**RE: Boettcher Limestone Quarry, Permit No. M-1977-348, Technical Revision No. 11 (TR-11),
Preliminary Adequacy Review**

Revise the groundwater monitoring program to include a background monitoring well (MW-8), and depending on the results of water quality data collected from that well, also include a compliance monitoring well (MW-9).

[View of entire permit area](#)

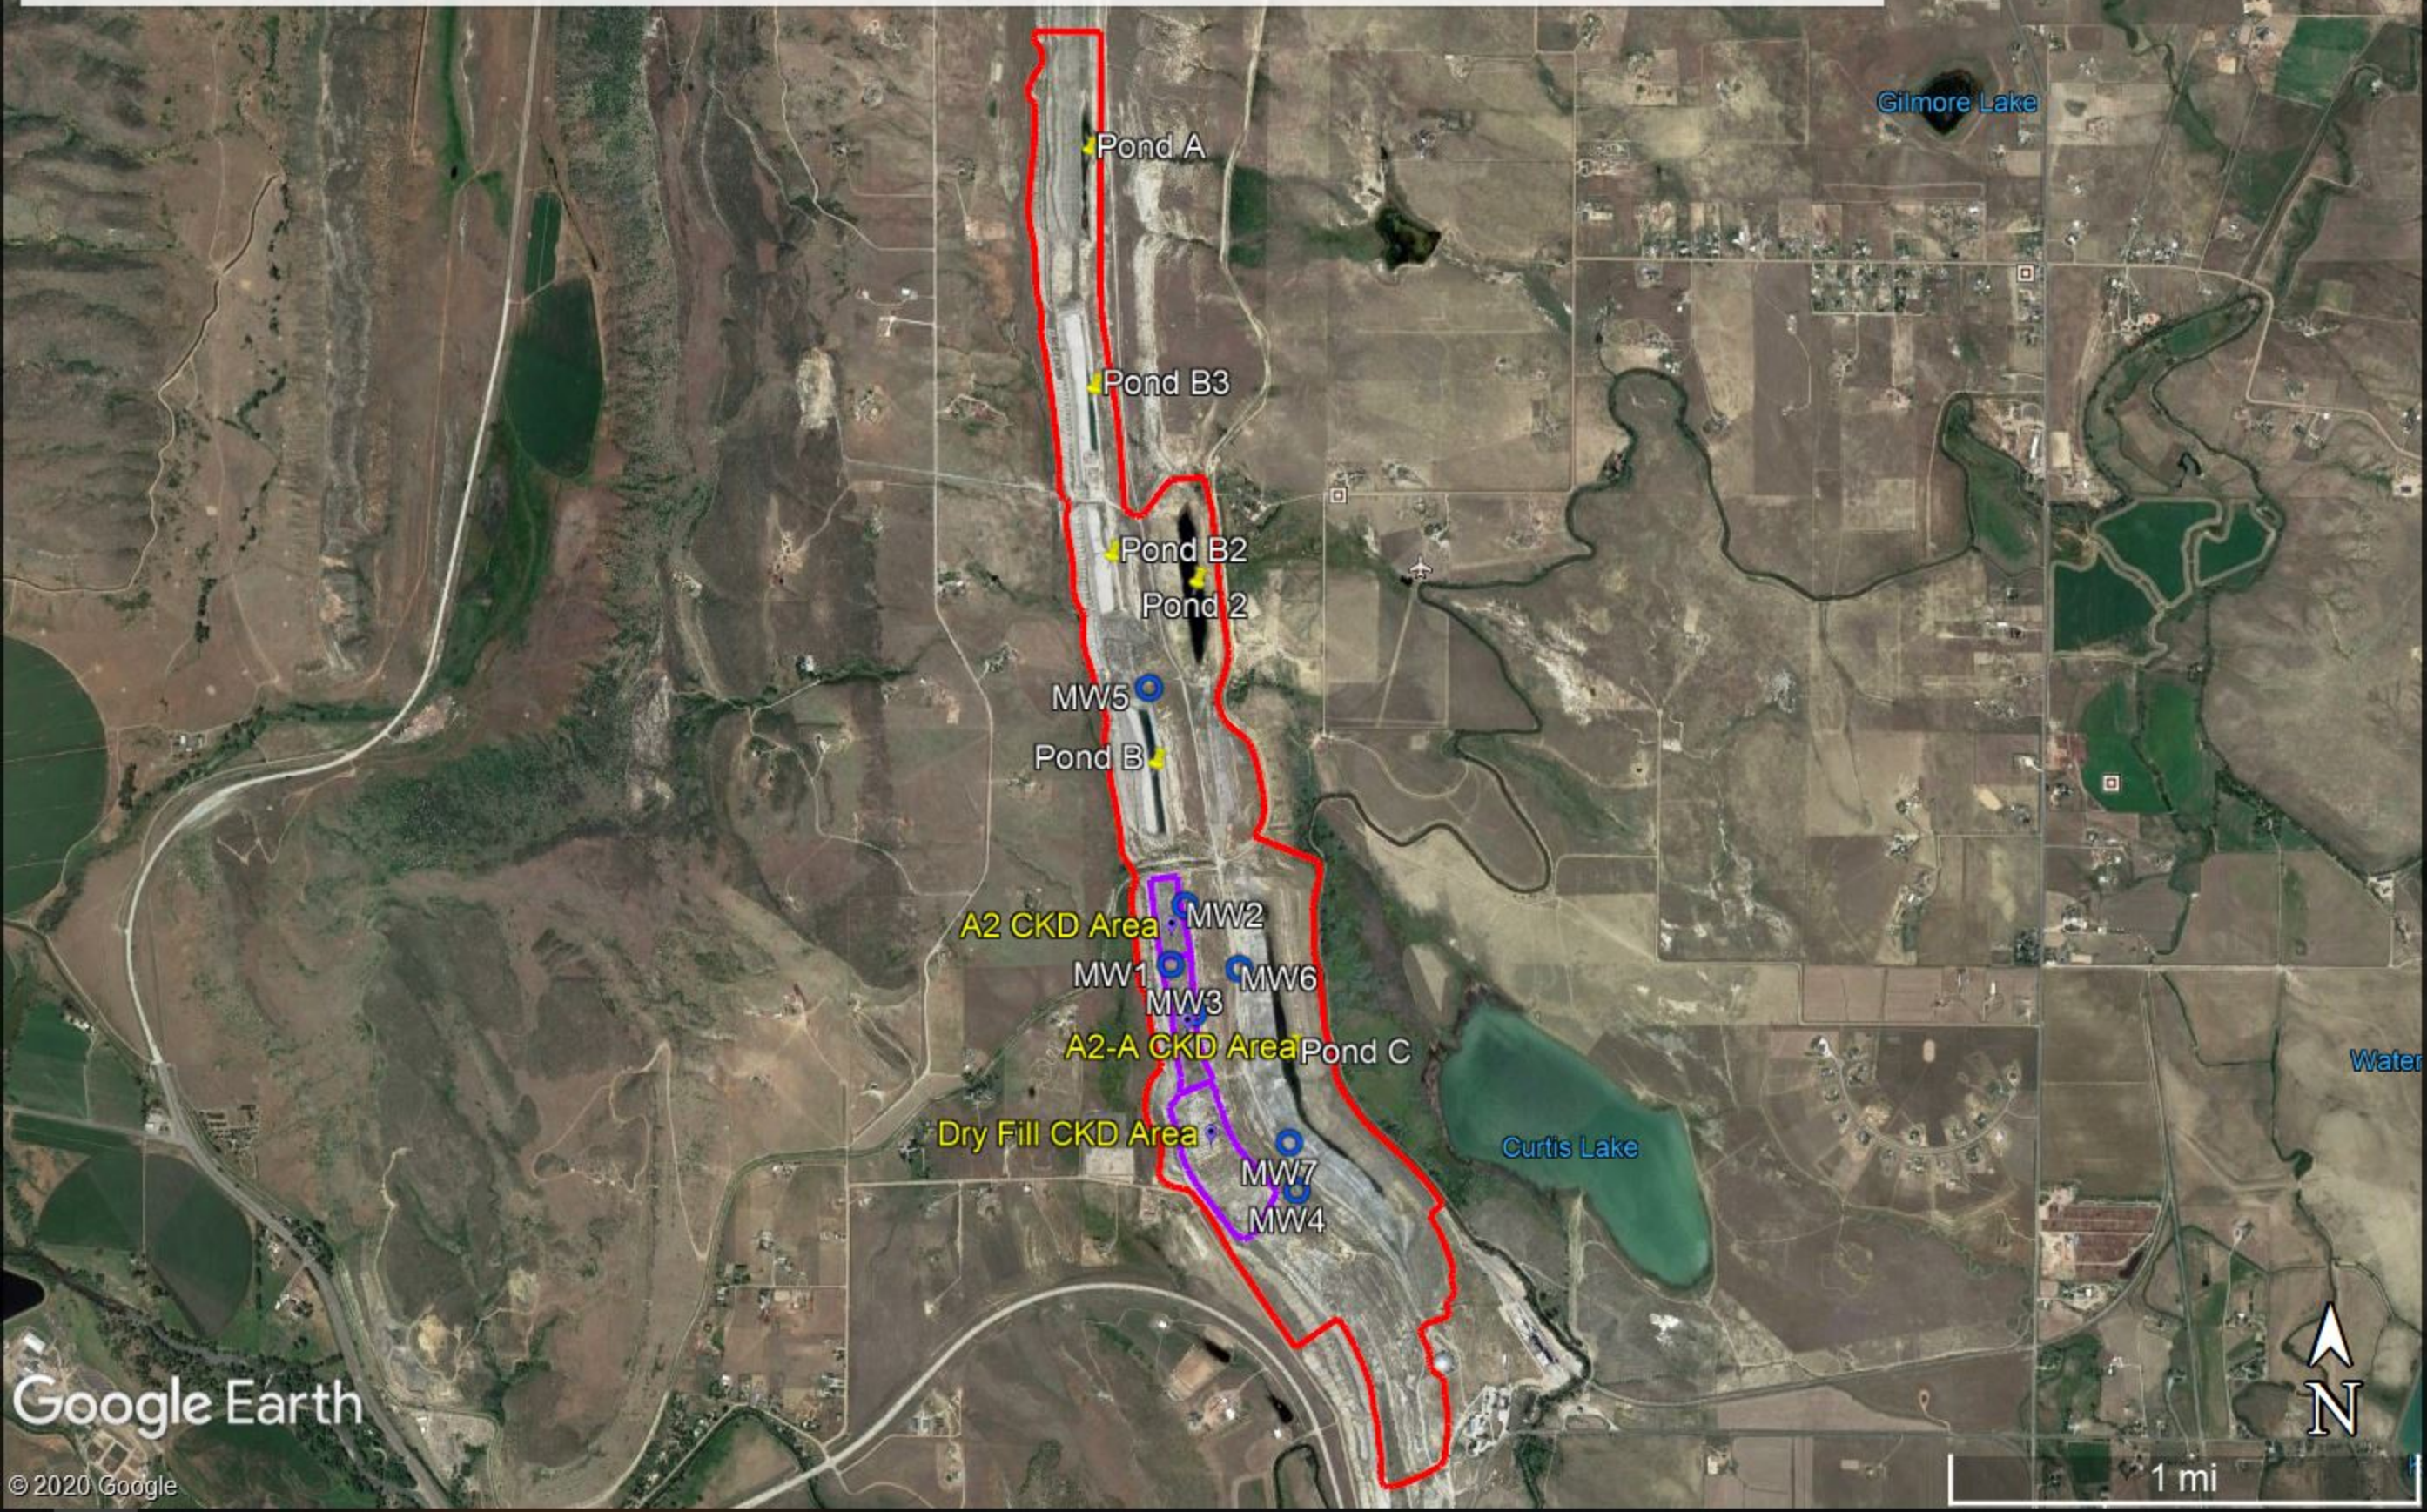
- 1) On Figure 1 – Site Location Plan, the permit boundary depicted is not accurate. Specifically, the shape of the boundary depicted on this figure does not match the shape of the approved boundary (see enclosed Google Earth images showing boundary after AR-4 approval). Additionally, the boundary depicted is shifted to the east, so that its western edge overlaps the CKD disposal areas. Please revise the permit boundary depicted on this figure to match the approved permit boundary.
